PARTS & SERVICE NEWS

REF NO.	AT04185
DATE	July 2, 2004

SUBJECT: REPAIR PROCEDURE FOR OIL LEAKAGE OF ENGINE STARTING MOTOR AND OVERHEATING OF FLYWHEEL HOUSING

APPLICATION GD555-3A Motor Grader S/N 10001 and up
 GD555-3C Motor Grader S/N 50001 and up
 GD655-3 Motor Grader S/N 1001 and up
 GD655-3A Motor Grader S/N 10001 and up
 GD655-3C Motor Grader S/N 50001 and up
 GD655-3Y Motor Grader S/N 4001 and up
 GD675-3A Motor Grader S/N 10001 and up
 GD675-3C Motor Grader S/N 50001 and up

Fig. 1

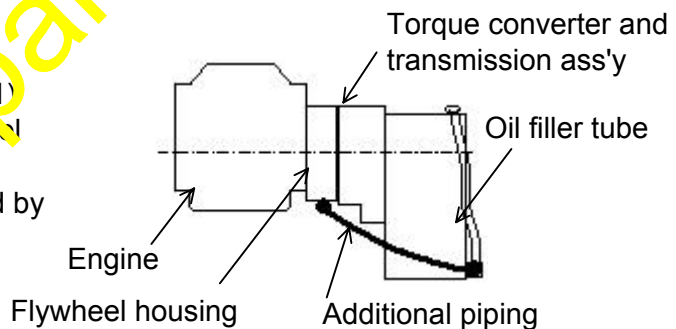
The bottom section of the flywheel housing and the transmission oil feeding tube are to be connected by an additional piping.

Fig. 2

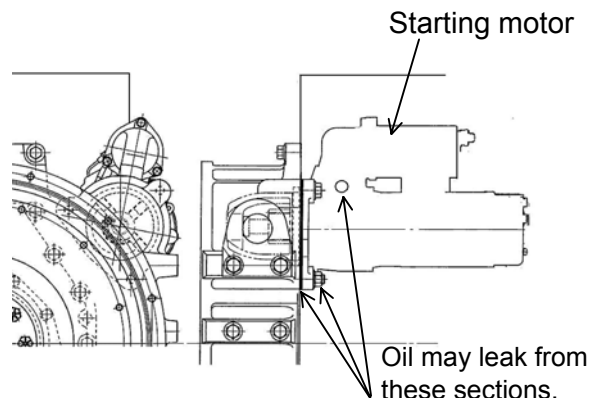
1. After screwing stud-bolts in each of the through threaded holes at 2 places on the starting motor mounting surface of the flywheel housing, each of the stud-bolt is to be tightened by the matching nut.
2. Liquid gasket is to be applied onto the gasket at the mounting section of the starting motor.

Fig. 3

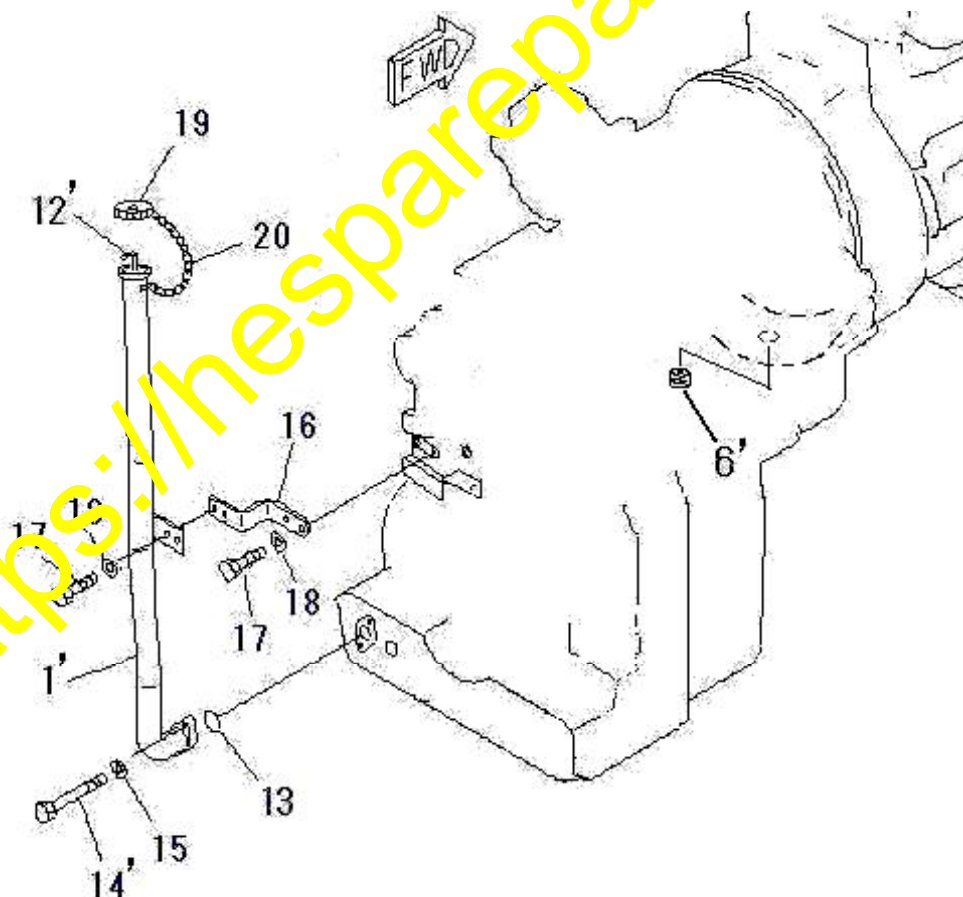
- 1) Remove the transmission oil feeding tube (1').

- 1) Removal of the drain plug (6') of the flywheel housing of engine.

Fig. 4

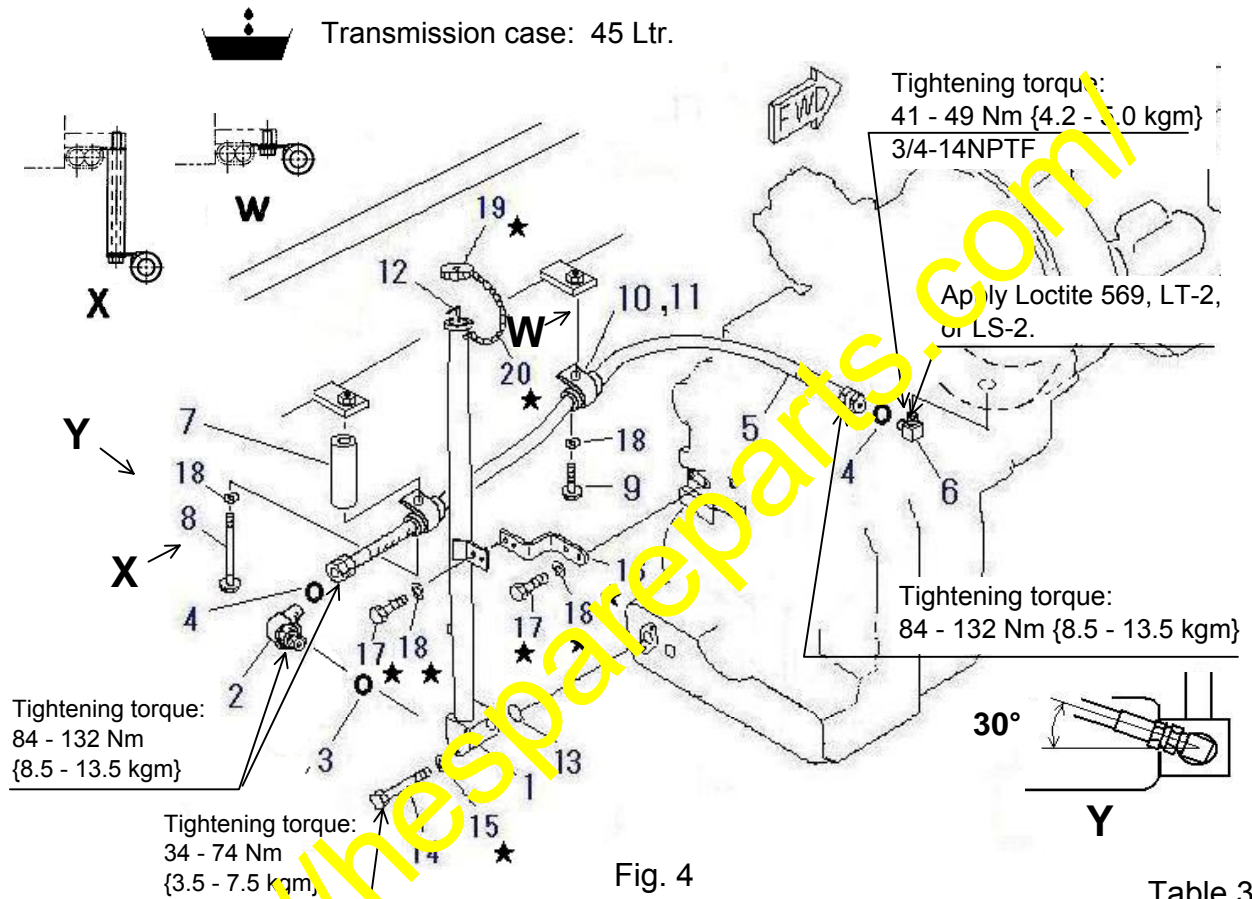
- 1) Install the transmission oil filler tube (1).
- 2) Install the elbow (6) to the drain plug of the flywheel housing.
- 3) Install the hose (5) and hose fixing clips and their related parts.

- 4) Replace the oil level gauge (12).
- 5) Refill the transmission case with oil and inspect the oil level.

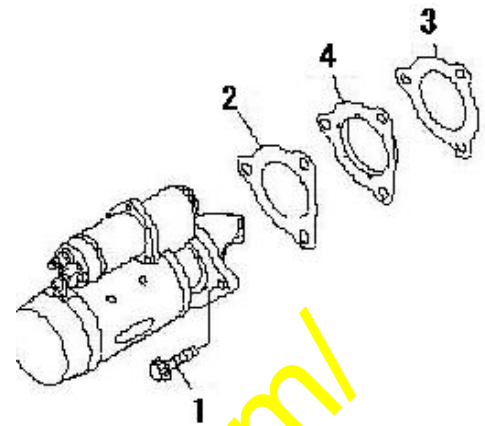
- 1) Remove the bolts (1), gaskets (2 and 3) and the spacer (4).
- 2) Remove the starting motor.

Fig. 6

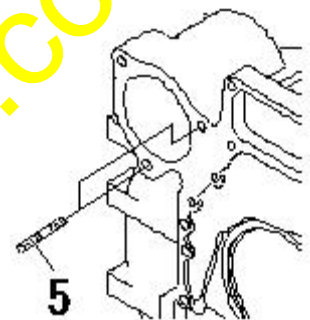
- 1) Screw the stud-bolts (5) in each of the through threaded holes at 2 places, among the starting motor mounting bolt holes on the flywheel housing.

Note) Screw the threaded side with 13-2 applied of the stud-bolt (5), into the flywheel housing side.

Fig. 7

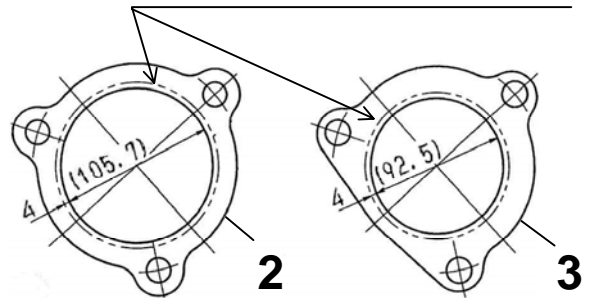
- 2) Apply liquid gasket onto both surface of the new gaskets (2) and (3) as per Fig. 7.

Apply liquid gasket onto both surface of these new gaskets along the instructed circumference at a thickness of $\Phi 1$ mm.

Fig. 8

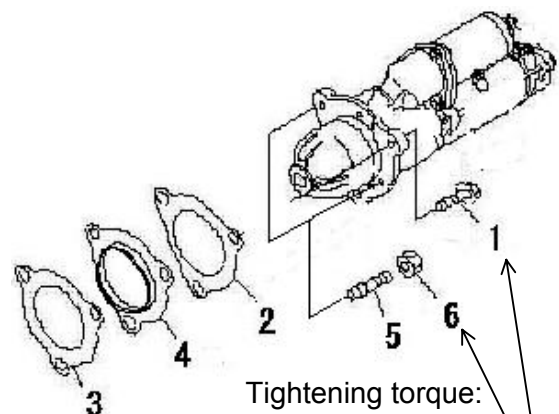
- 3) Install the starting motor using the bolt (1) and nuts (6) as it has been.

- 4) In case oil has penetrated inside the starting motor, replace the starting motor also with a new one.

Tightening torque:
54 - 123 Nm
{5.5 - 12.5 kgm}

Fig. 9

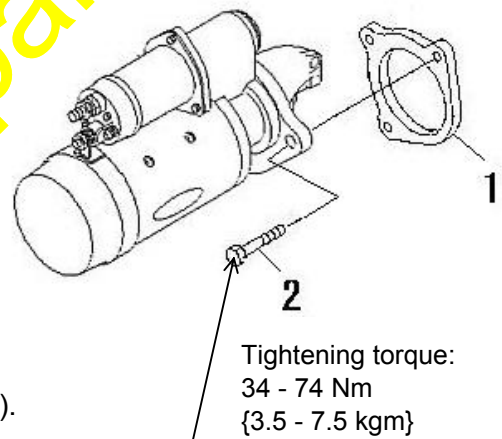
1) Remove 3 pcs. of the bolts (2).

1) Apply liquid gasket to both surfaces of the new gaskets (1).
Refer to the item 2) of the Section 1-3-1 (3).

2) Install the starting motor using 3 pcs. of the bolts (2) as it has been.

3) In case oil has penetrated inside the starting motor, replace the starting motor also with a new starting motor.

(Since starting motor mounting holes, at all the 3 places, on the flywheel housing on the GD555-3 are not through holes, it is not necessary to install the stud-bolts like in case of the GD655-3 and GD675-3.)
